**Evaluation of Advanced  
Cladding and Structural  
Material (M5) in  
PWR Reactor Fuel**

BAW-10227-A  
February 2000

**SUBJECT: REVISED SAFETY EVALUATION (SE) FOR TOPICAL REPORT BAW-10227P:  
"EVALUATION OF ADVANCED CLADDING AND STRUCTURAL MATERIAL (M5)  
IN PWR REACTOR FUEL" (TAC NO. M99903)**

Figure I-10.1  
Thermal Conductivity vs Temperature

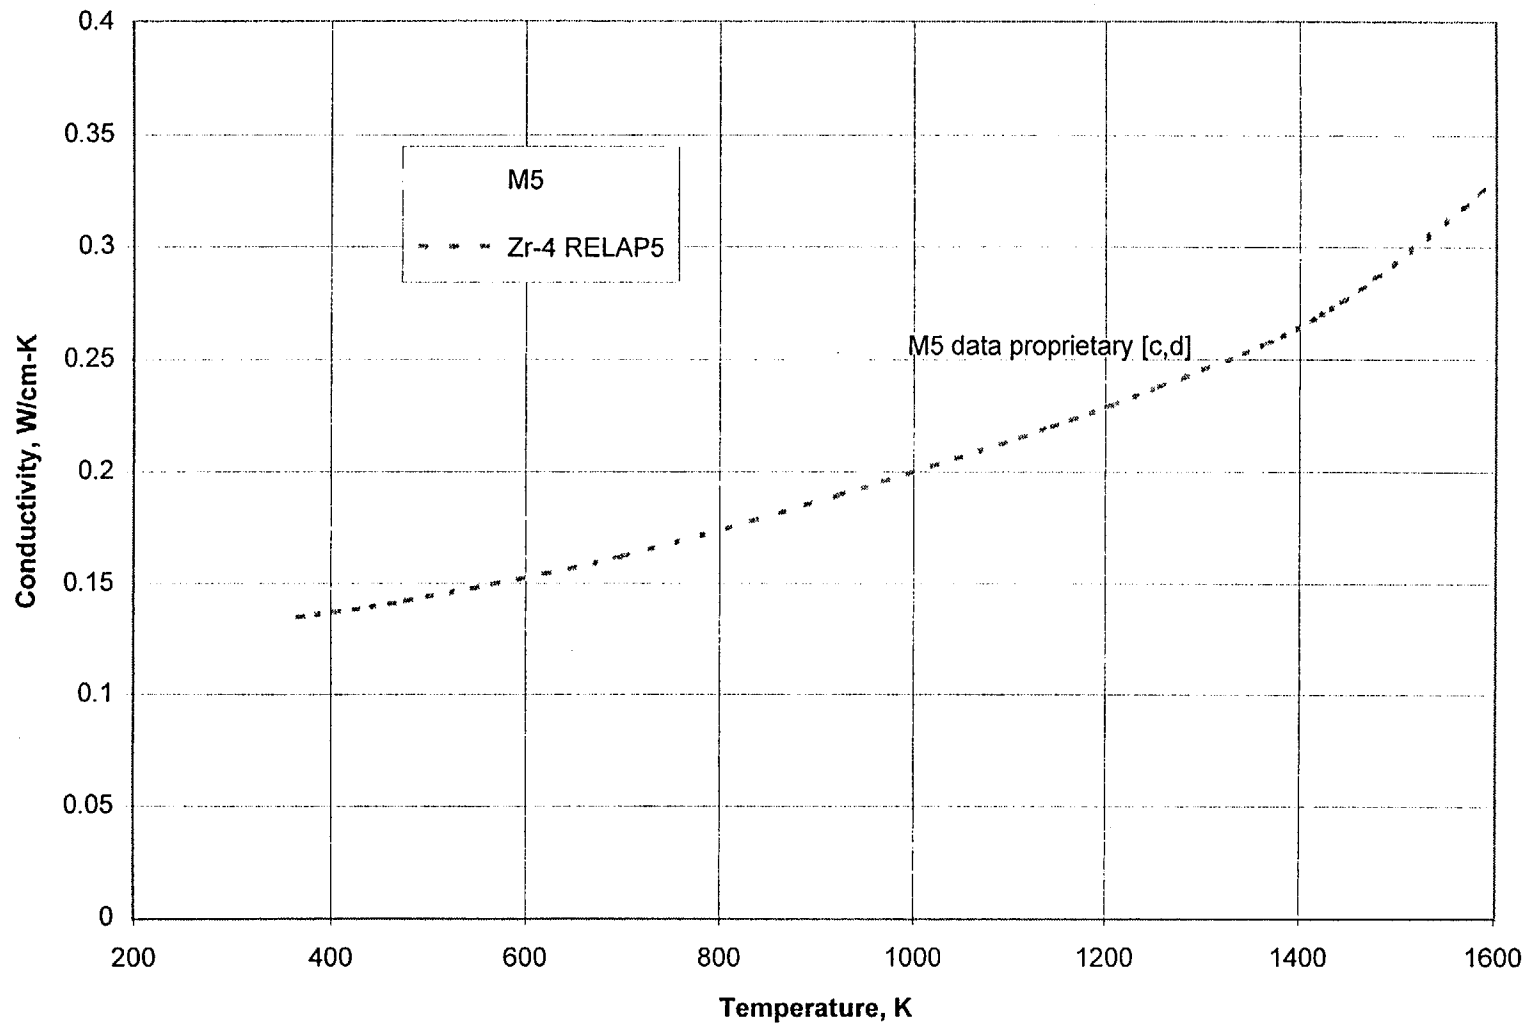
As stated in the text of BAW-10227, many of the materials properties published with BAW-10227 were extrapolated from Zircaloy in order to provide a demonstration of the analytical models for the M5 alloy. This was true for the thermal conductivity, because testing had not been completed at the time of publication. Testing has now been completed for the thermal conductivity of M5. Figure I-10.1 shows both the Zircaloy-4 LOCA and Safety Analysis thermal conductivity (labeled Zr-4 RELAP5 on Figure A-2 of BAW-10227) and the M5 conductivity fit that will be used for the LOCA and Safety Analyses. However, the LOCA and Safety Analysis codes use tabular input as given below. As with all the material properties, current values will be maintained in a controlled document at our Lynchburg Virginia Offices.

As can be observed in Figure I-10.1 the value of conductivity for M5 is higher than for Zircaloy. This difference will promote a somewhat more efficient transfer of energy from the pellet through the cladding to the coolant and should allow a larger amount of energy to be transferred to the coolant during accident phases when cooling is present. Therefore, the effect should be slightly lower cladding and fuel temperatures. A slight benefit should be observed during LOCA. Over-heating events involve the determination of a system pressure or the occurrence of CHF as limits. These transients may experience some increase in consequence. However, the heat transfer from the fuel pellet remains limited by the fuel to clad gap coefficient, minimizing the consequence of the change. Because of this, it is not considered necessary to evaluate the change explicitly. Over-cooling transients are driven by coolant temperature. The slight increase in energy transport will again provide some benefits.
